**HAMMOND HIGH SCHOOL
RENOVATION AND ADDITION**

ADDENDUM NO. 2

DATE: March 6, 2020

PROJECT: Hammond High School Renovation and Addition
Columbia, Maryland
Architect Project No. 18011

FISHER, COLLINS, CARTER 10272 BALTIMORE NATIONAL PIKE ELLICOTT CITY, MD 21042 410-461-2855(P)	HAMMOND HIGH SCHOOL RENOVATION AND ADDITION ITEM: ADDITIONAL ROAD SIGN "DO NOT ENTER" SIGN AND RELOCATION OF 3 "FIRE LANE" SIGNS	SCALE: 1" = 40'
		ADDENDUM 02
		DATE: 3/06/20
		AD-C01

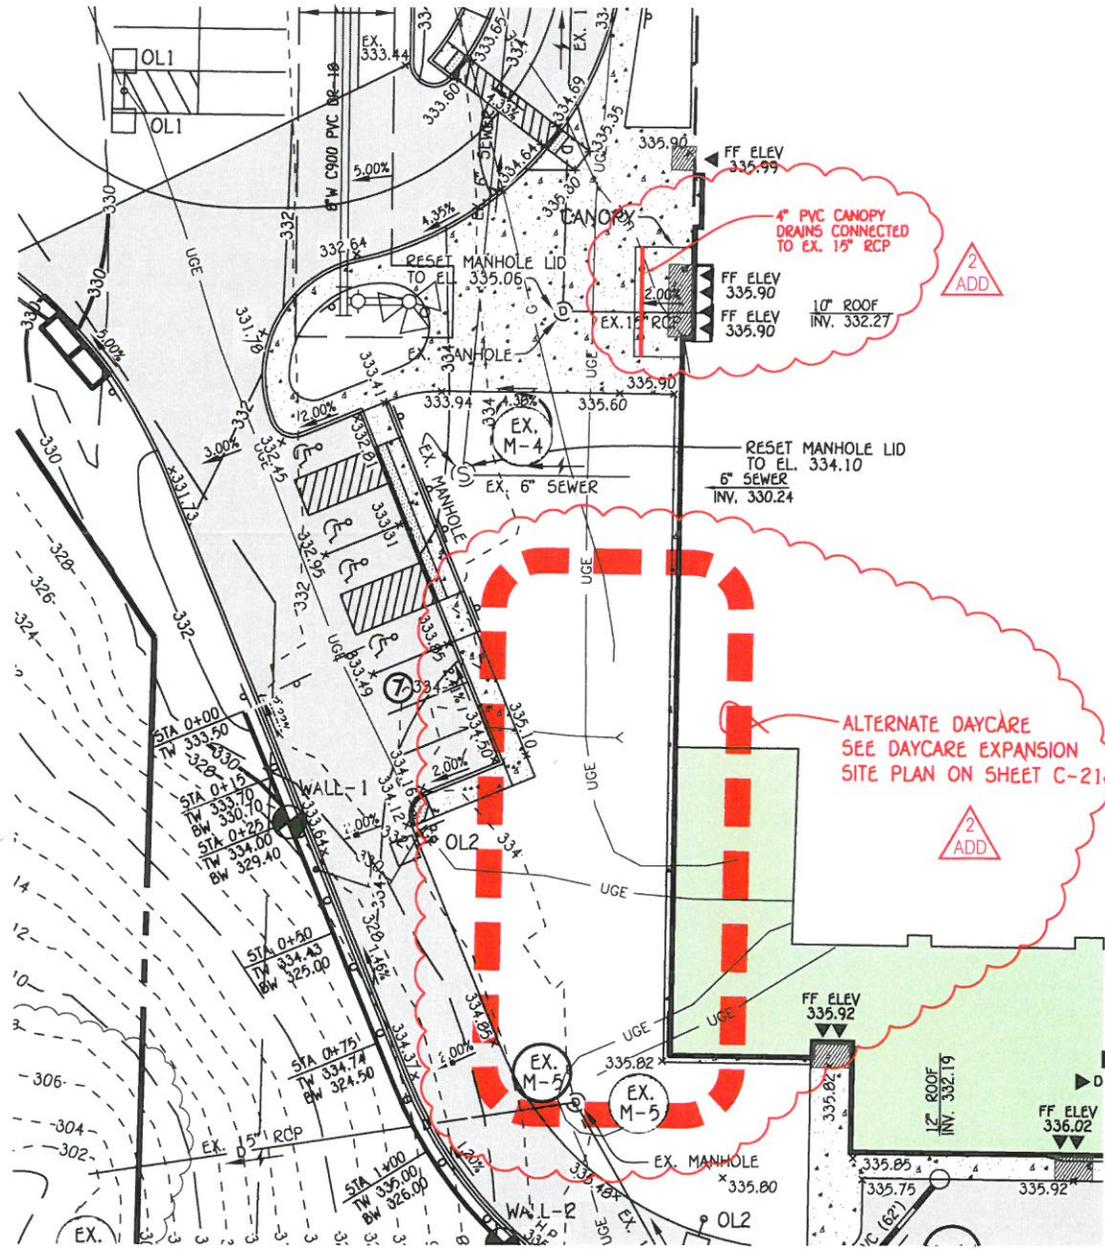
- Sheet C-4 – SITE DEVELOPMENT PLAN
 - **ADD** alternate callout, see AD-C02
 - **ADD** proposed drainage pipe from canopy, see AD-C02.
 - **ADD** proposed drainage pipe canopy, see AD-C03.
- Sheet C-6 – GEOMETRY PLAN AND STRIPING PLAN (C-6)
 - **ADD** additional signage, see AD-C01.
 - **ADD** additional signage, see AD-C04.
 - **ADD** references to architectural items detailed on the architectural plans, see AD-C04.
 - **ADD** stop bars in parking lot, see AD-C05.
 - **ADD** crosswalk across main entrance to the site, see AD-C06

A2.53
 A2.54
 REF SHT NO.: A2.56

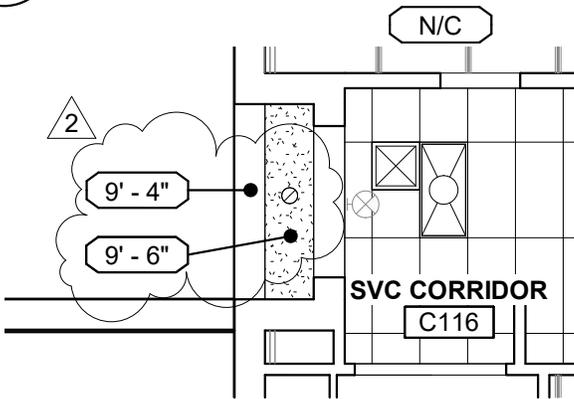
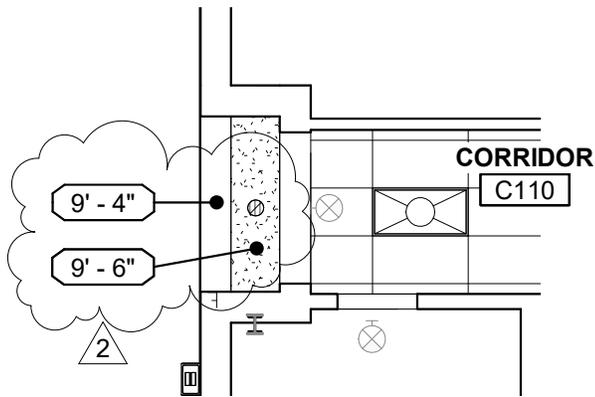
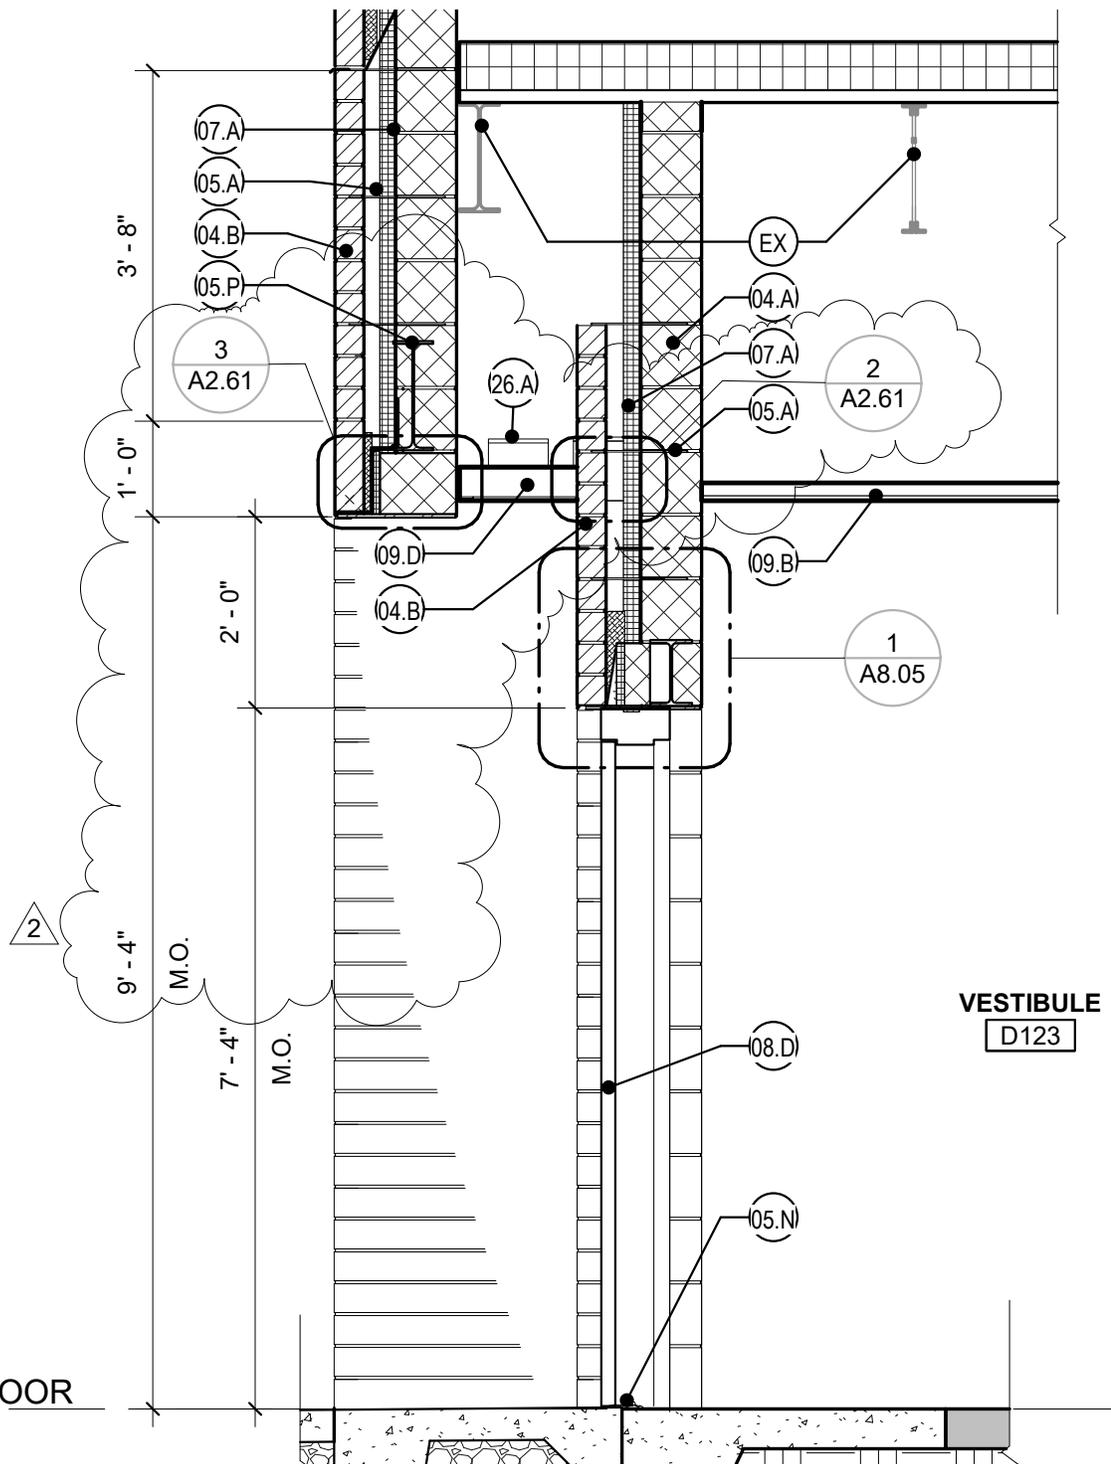
- Sheet A2.53 – RCP – FLOOR 1 – AREA C
 - **ADD** elevation tags to exterior MDO soffits and masonry lintels as indicated in AD-A01.
- Sheet A2.54 – RCP – FLOOR 1 – AREA D

- **ADD** elevation tags to exterior MDO soffits and masonry lintels as indicated in AD-A01.
- Sheet A2.56 – RCP – FLOOR 1 – AREA G
 - **ADD** elevation tags to exterior MDO soffits and masonry lintels as indicated in AD-A01.

REF SHT NO.: A4.05
 SCALE: 1/2" = 1'-0"
 ADDENDUM: 02
 DATE: 02/28/20

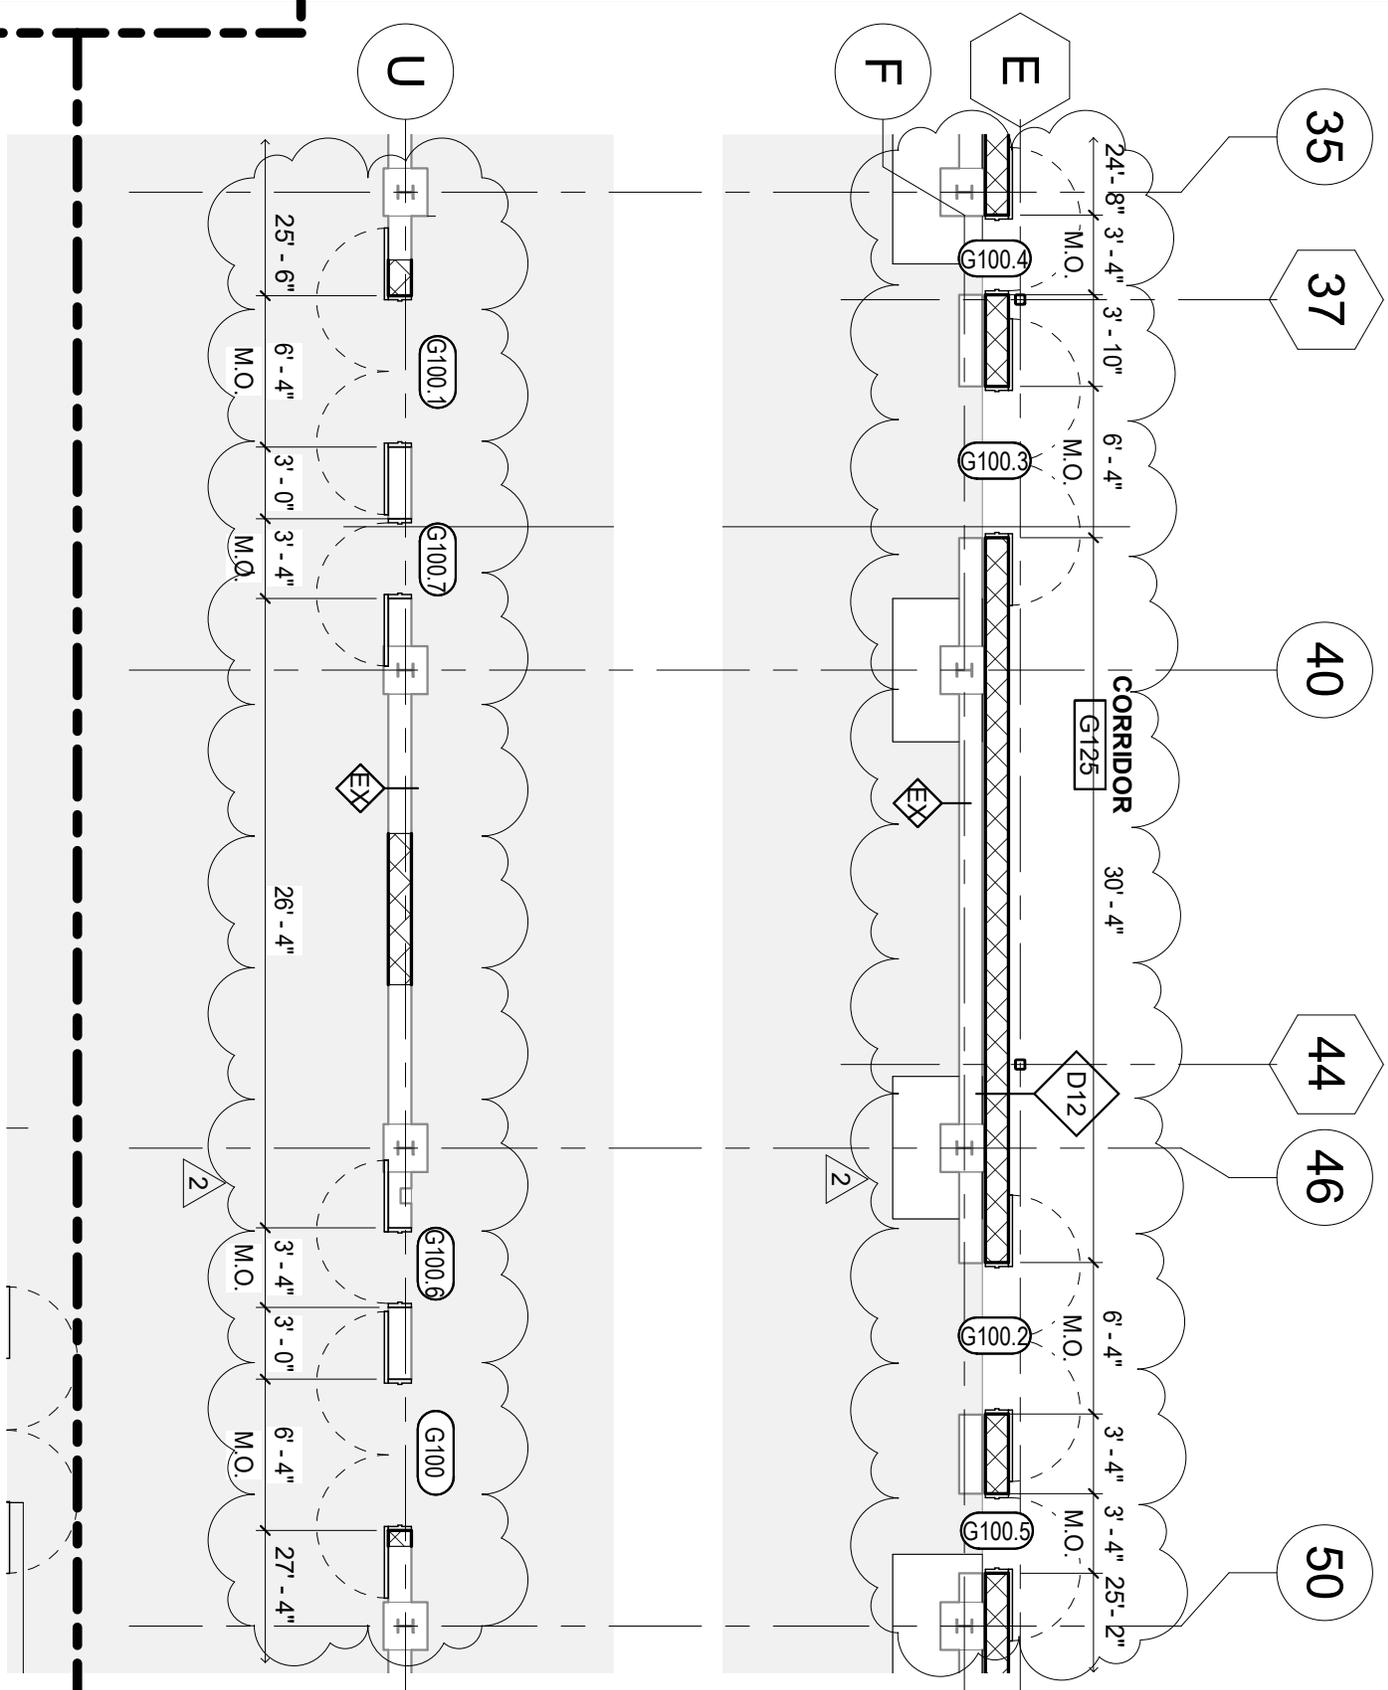
- Sheet A4.05 – RCP – FLOOR 1 – AREA C
 - **REVISE** MDO soffit and masonry opening elevations at typical alcove as indicated in AD-A02.
- Sheet A6.04 – VERTICAL CIRC. PLANS AND DETAILS - AUDITORIUM & CATWALK

AD-A03

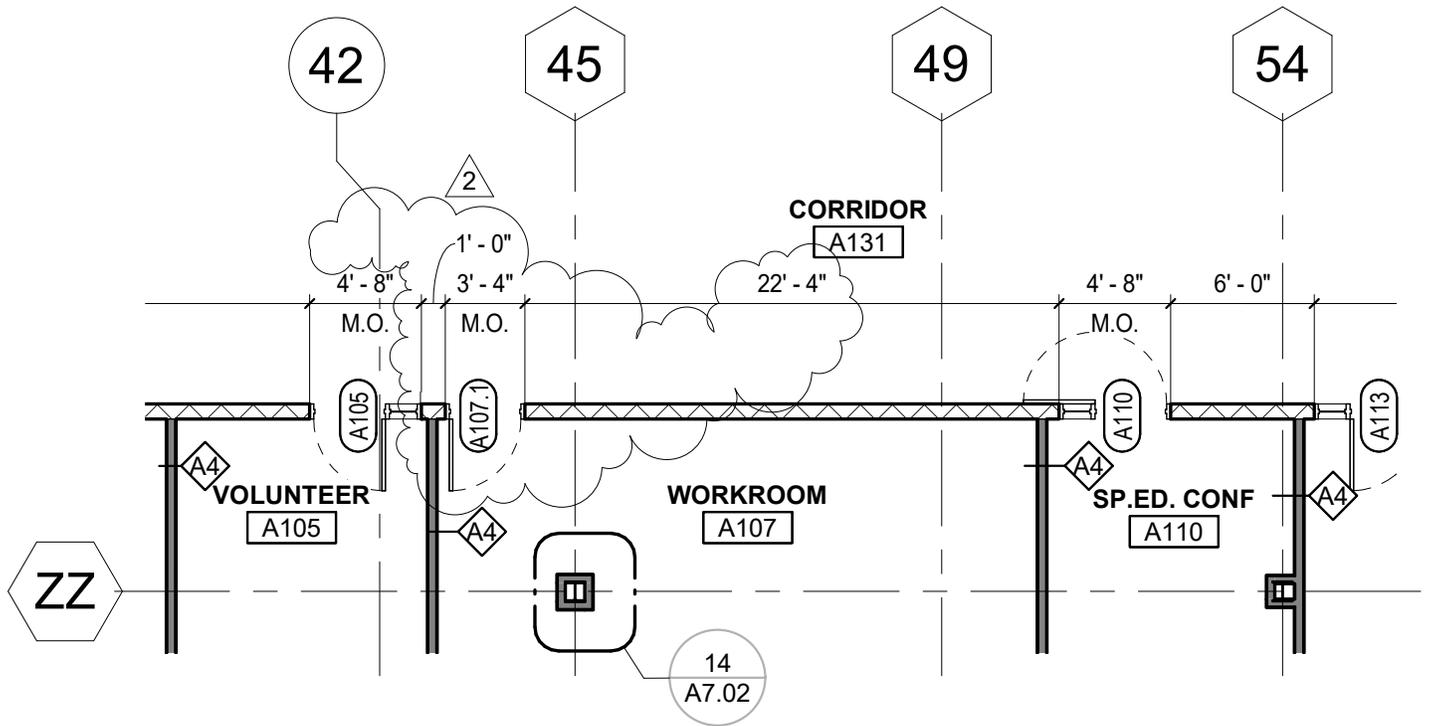
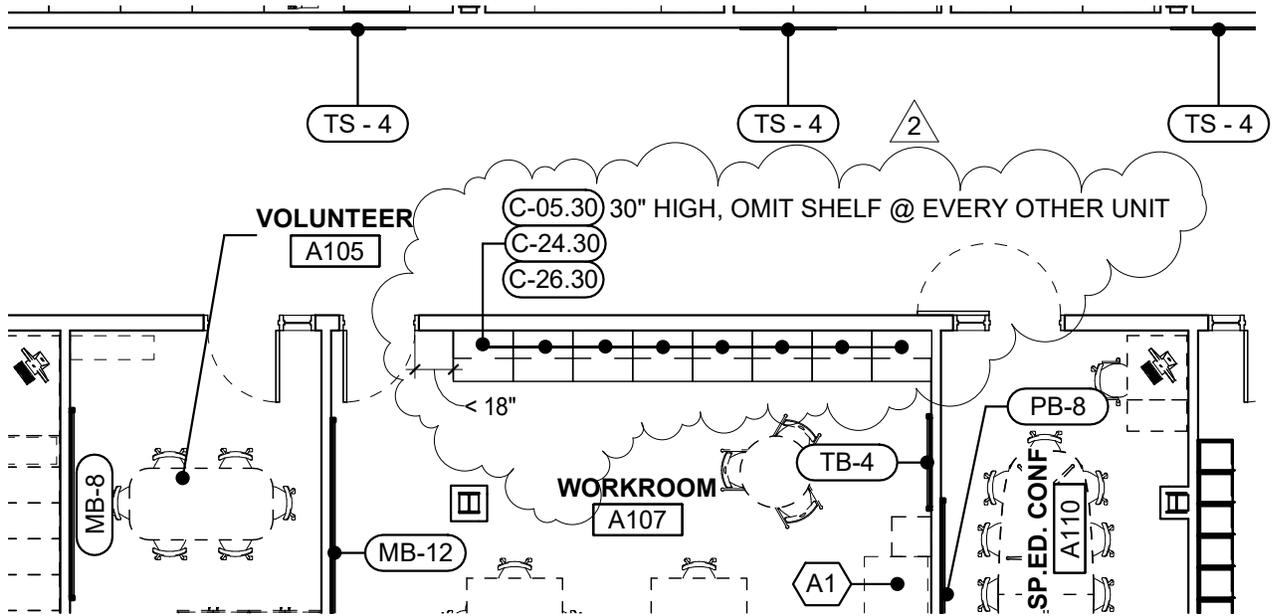
- Sheet A2.01 - FLOOR PLAN - FLOOR 1 - AREA A
 - **REVISE** door location as indicated in AD-A04.
- Sheet A2.06 - FLOOR PLAN - FLOOR 1 - AREA G
 - **REVISE** door locations as indicated in AD-A03.

AD-A04

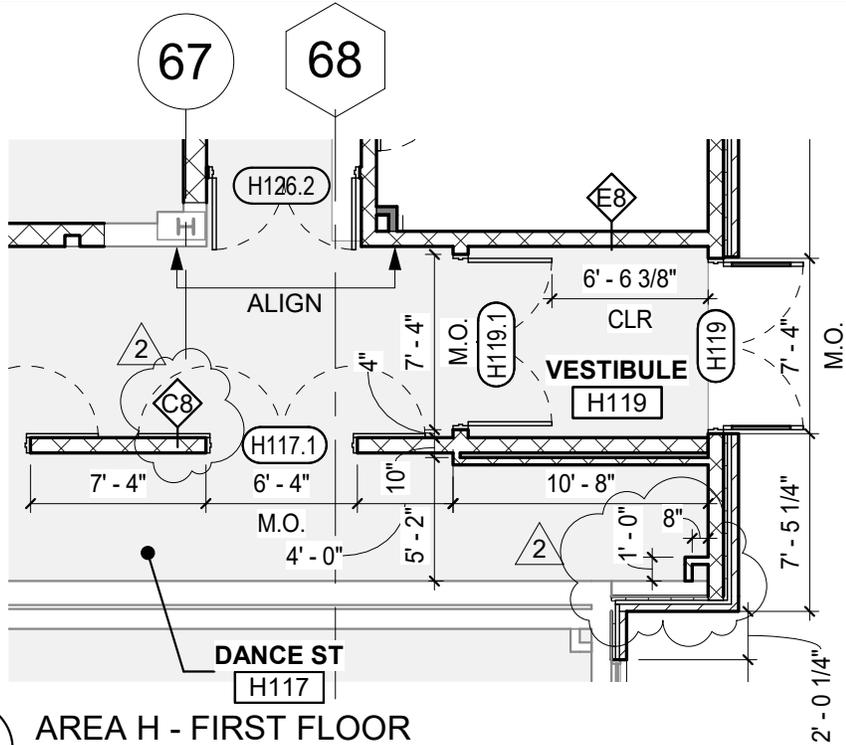
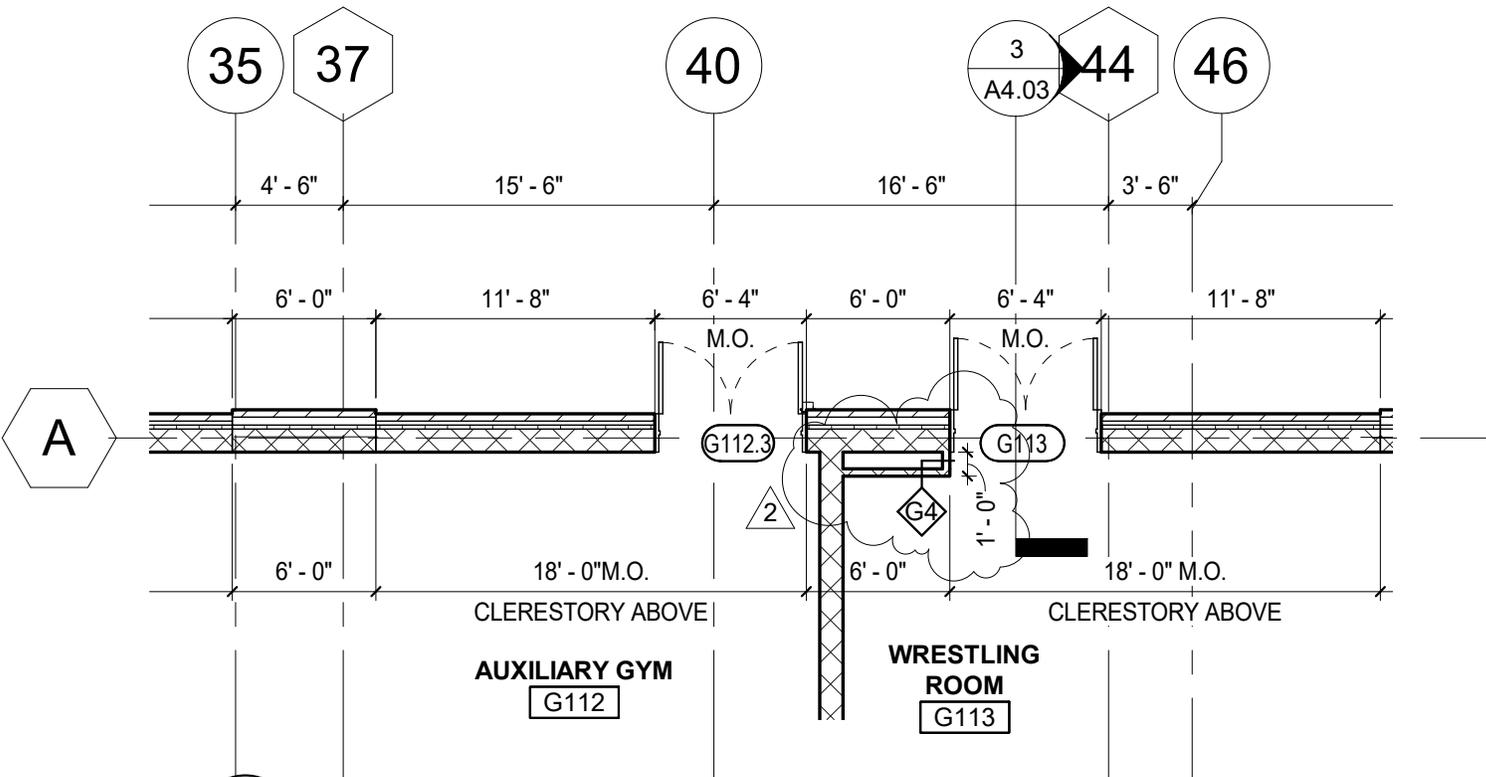
- **REVISE** Frame type to M1 for doors G100.4, G100.5, G100.6 & G100.7
- Sheet A9.01 – PARTIAL CASEWORK PLAN - FIRST FLOOR - AREA A
 - **REVISE** casework on north wall of room A107 as indicated in AD-A04
